ORIGINATION FORM

Proposed Revisions to a Standard Plans Index
(Please provide all information – Incomplete forms will be returned)

Index Number: **700-110**
Sheet Number (s): 1 of 1
Index Title: Mounting Exit Number Panels to Highway Signs

Changed Index title to "Mounting Exit Number Panels to Overhead Highway Signs"; Change Notes; Editorial changes to ELEVATION; Changed SECTION A-A Bolt notes

CHANGED NOTES
ELEVATION

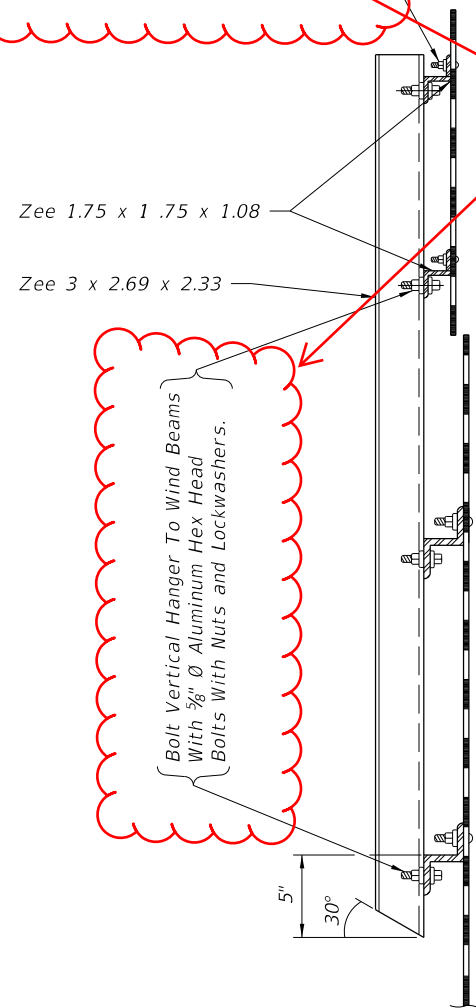
NOTE: Exit numbering panel shall be located to the right side for right exit and to the left for left exit.

Mounting of Exit Numbering Panels To Highway Signs

Bolt Sign to Zee Using 1/4" Ø Aluminum Flat Head Bolts, Nuts and Lock Washers (Typ.) 12" Max Spacing

Bolt Vertical Hanger To Wind Beams With 5/8" Ø Aluminum Hex Head Bolts With Nuts and Lockwashers.

SECTION AA

CHANGED CALL OUTS

CHANGED NOTES

CHANGED TO: MOUNTING EXIT NUMBER PANELS TO OVERHEAD SIGNS
